Change Order

PROJECT: (Name and address)
Illini Central Addition and Renovation
208 Northwest Avenue
Mason City, IL 62664

Change Order Number: 014

RFP 37: Toilets / Ramp - ADD \$216,328

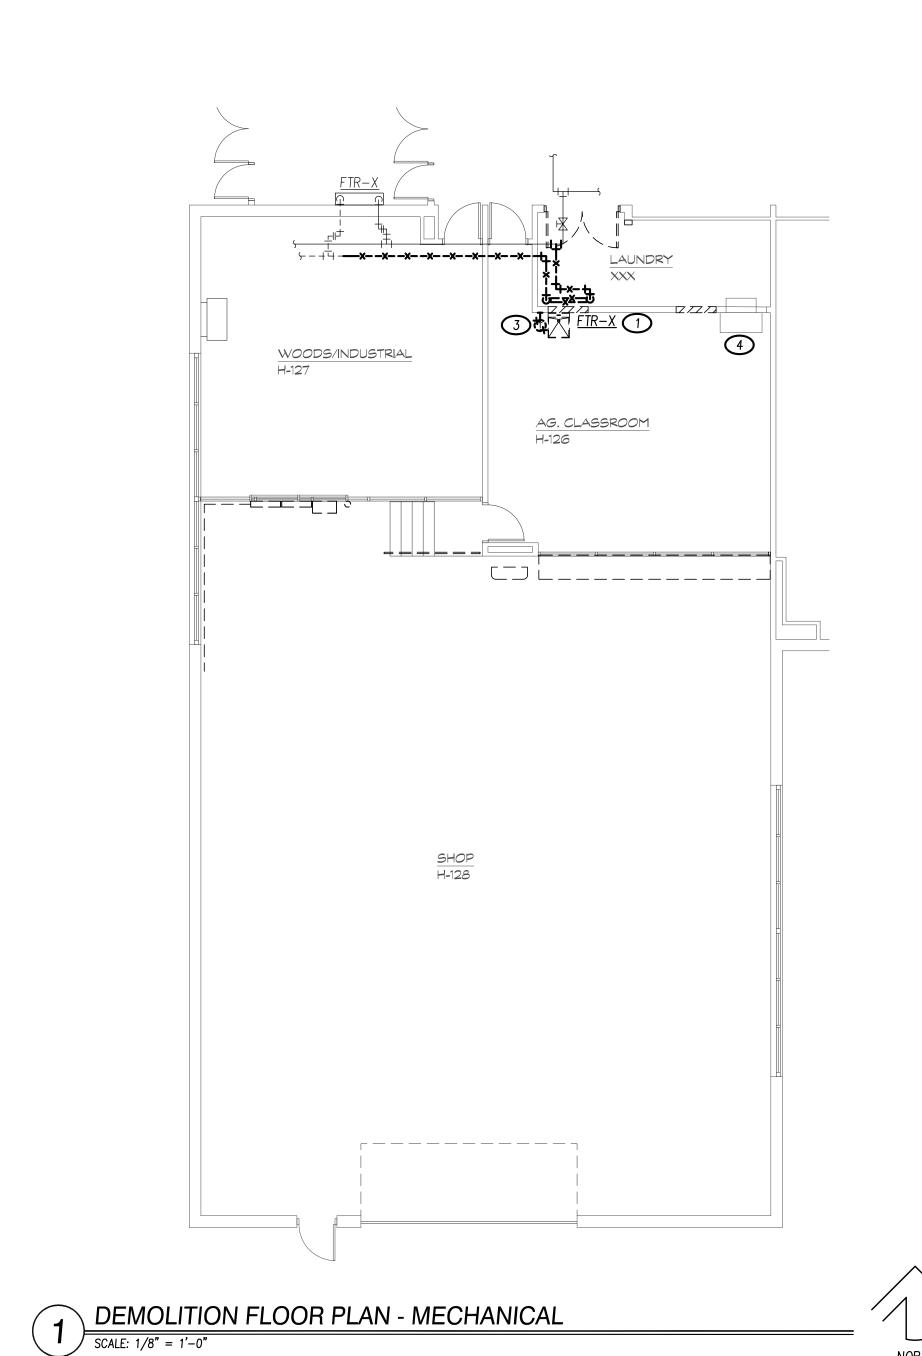
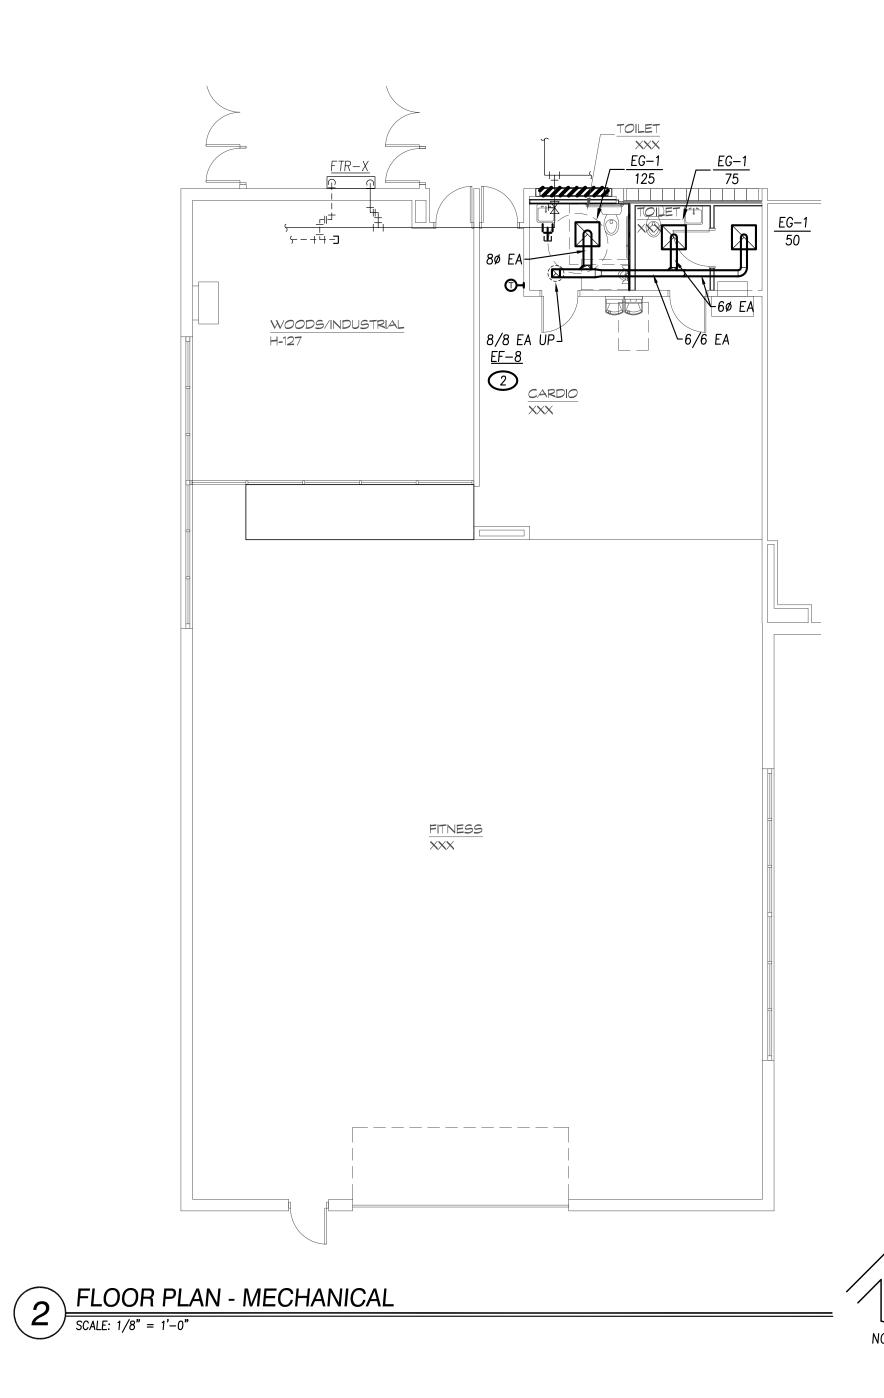
- PROVIDE ALL MATERIALS AND LABOR TO DEMOLISH FINNED TUBE HEATING SYSTEM AND ALL ASSOCIATED PIPING AND PIPING ENCLOSURES. CAP PIPING BACK AT MAIN.
- FURNISH AND INSTALL NEW EXHAUST FAN PER MANUFACTURER'S INSTALLATION INSTRUCTIONS. REFER TO 1/M401.
- 3 RELOCATE EXISTING THERMOSTAT AND PNEUMATIC CONTROLS.
- 4 EXISTING MECHANICAL UNIT AND ASSOCIATED DUCK WORK TO REMAIN.

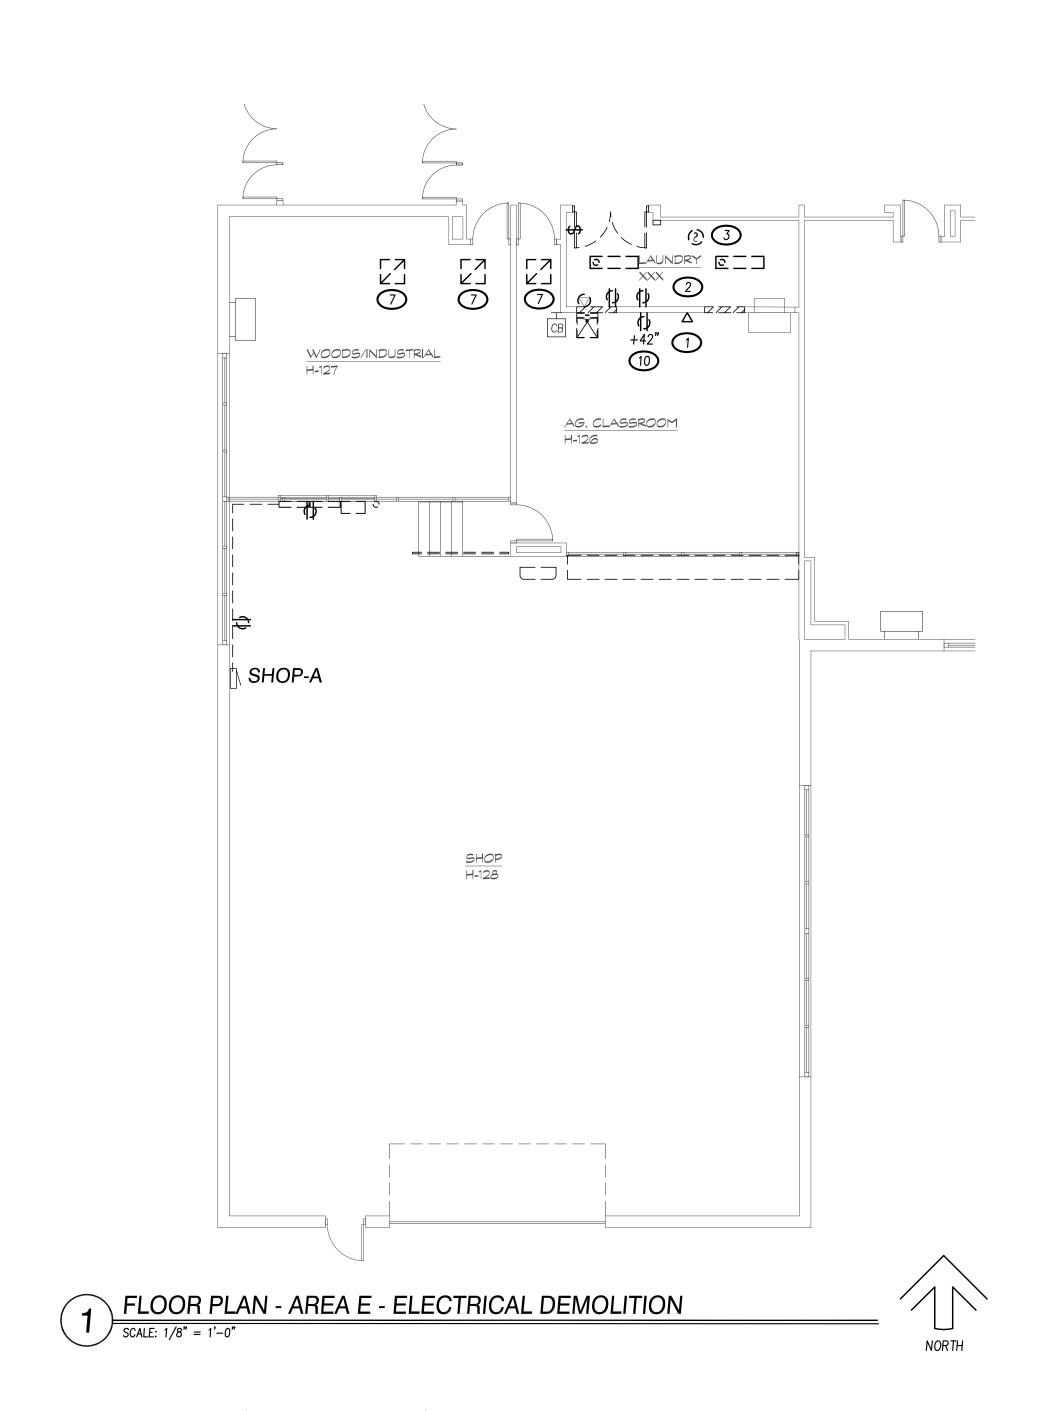
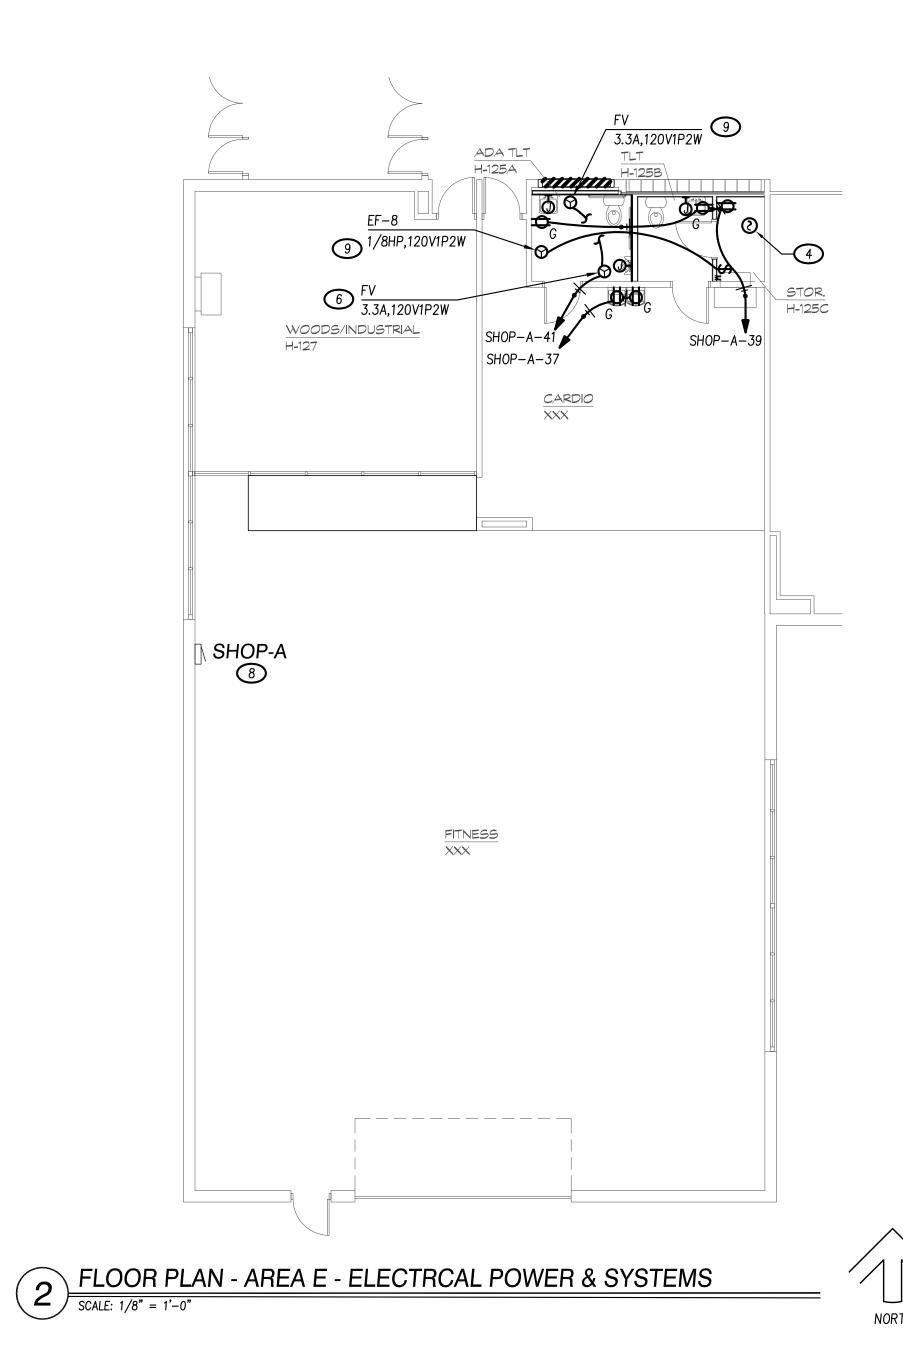
COMPLETELY DEMOLISH EXISTING LIGHTING. EXISTING CIRCUITRY IS TO SERVE NEW

REMOVE AND DEMOLISH EXISTING SMOKE DETECTOR. REINSTALL SMOKE DETECTOR IN NEW STORAGE ROOM. REFER TO DETAIL 2 ON SHEET E113 FOR FURTHER INFORMATION.

REINSTALL PREVIOUSLY REMOVED SMOKE DETECTOR. ALL WIRING SHALL BE EXTENDED AS REQUIRED TO RECONNECT EXISTING DEVICE IN NEW LOCATION.

5 FURNISH AND INSTALL NEW LIGHTING. CONNECT NEW LIGHTING EXISTING CIRCUITRY. EXTEND 2#12 & 1#12G IN 3/4" CONDUIT TO NEW LIGHTING.

6 FURNISH AND INSTALL EQUIPMENT CONNECTION TO NEW EXHAUST FAN. COORDINATE ALL REQUIREMENTS WITH MECHANICAL CONTRACTOR PRIOR TO INSTALLATION.

7 REMOVE AND REINSTALL LIGHTING TO ALLOW FOR ABOVE CEILING WORK BY OTHER TRADES. ALL DAMAGED CEILING TILES SHALL BE REPLACED.

8 FURNISH AND INSTALL NEW BREAKERS AS REQUIRED TO SERVE NEW LOADS. NEW BREAKERS SHALL MATCH EXISTING TYPE AND RATING, EXISTING PANEL IS A SQUARE D NOOB PANEL. EXISTING BREAKERS HAVE A 10KA RATING.SPARE BREAKERS FROM OWNER REMOVED SHOP EQUIPMENT SHALL BE REPLACED WITH NEW SINGLE POLE, 20-AMPERE BREAKER TO SERVE NEW LOADS.

9 COORDINATE FLUSH VALVE AND ASSOCIATED JUNCTION BOX LOCATIONS WITH PLUMBING CONTRACTOR PRIOR TO ROUGH-IN. URINAL AND SINKS ARE HARDWIRED CONNECTIONS. ALL WORK SHALL BE COORDINATE WITH ALL TRADES PRIOR TO BID.

REMOVE AND DEMOLISH EXISTING RECEPTACLE. FURNISH AND INSTALL A STAINLESS STEEL COVER PLATE OVER EXISTING BACK BOX.
